**From:** Maria Calderon  
**Sent:** 08 May 2019 18:46  
**To:** Hilary Saunders  
**Cc:** Planning  
**Subject:** Thirley Cotes Farm

**From:** [Maria Calderon](#)  
**To:** [Hilary Saunders](#); [Planning](#)  
**Subject:** Thirley Cotes Farm NYM/2019/0101/LB and NYM/2019/0100/FL  
**Date:** 03 April 2019 18:49:06

**From:** [Maria Calderon](#)  
**To:** [Hilary Saunders](#)  
**Cc:** [Planning](#)  
**Subject:** Thirley Cotes NYM/2019/0100/FL and NYM/2019/0101/LB  
**Date:** 19 March 2019 22:49:44

**Application for conversion of and extension to redundant buildings to form 3 no. holiday cottages with associated parking, amenity spaces and landscaping works (revised scheme to NYM/2018/0247/FL) (part retrospective) at Thirley Cotes Farm, Waite Lane, Harwood Dale, Grid Reference 497659 495103**

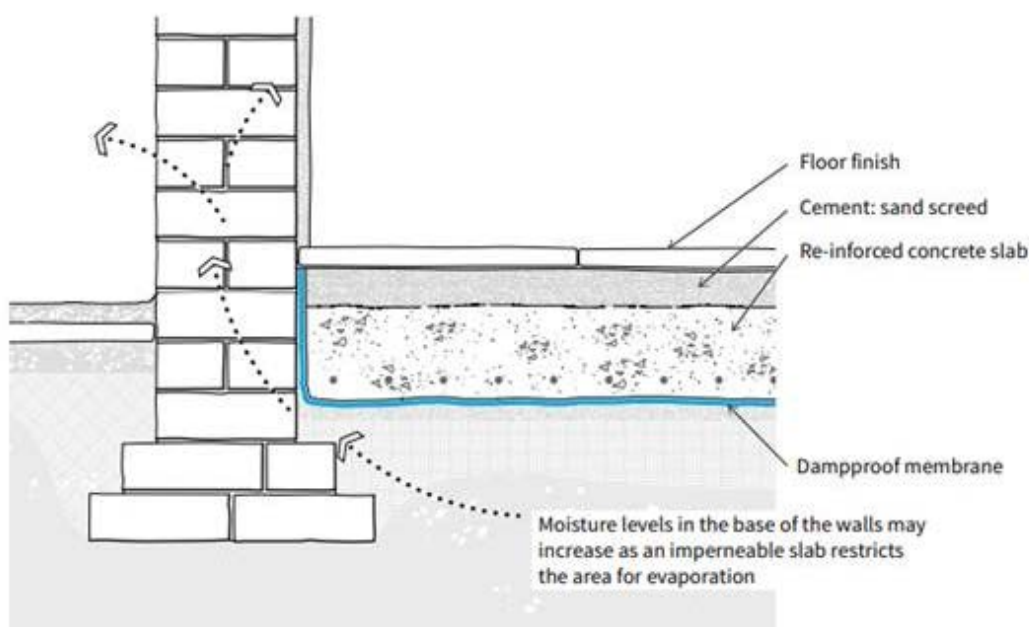
Regarding the concrete floor - the following is taken from the current Historic England guidance which is freely available at <https://historicengland.org.uk/images-books/publications/eehb-insulating-solid-ground-floors/heag087-solid-floors/>

*Significant historic fabric is often lost or damaged when this type of solid floor is introduced in traditional buildings. The relaying of a floor on a damp-proof membrane restricts the amount of moisture which can evaporate through the floor. The ground moisture is often displaced to the base of the walls where it can cause rising damp instead."*

As such in order to prevent any rising damp problems within the structure either a limecrete floor should be used or air airgap so that moisture is less concentrated through the walls. Although I admit this may still cause some damp issues, I was trying to find a solution that might suit us all. I accept that in the past this practice has been utilised, but it was recognised some time ago to cause problems and has not or should not have been a standard detail in traditional buildings for some time. A u-value of 0.2 could be met with 10mm wood fibre board and lime concrete floor which is well within the regulation for refurbishment. However, listed buildings are exempt from certain building regulations.
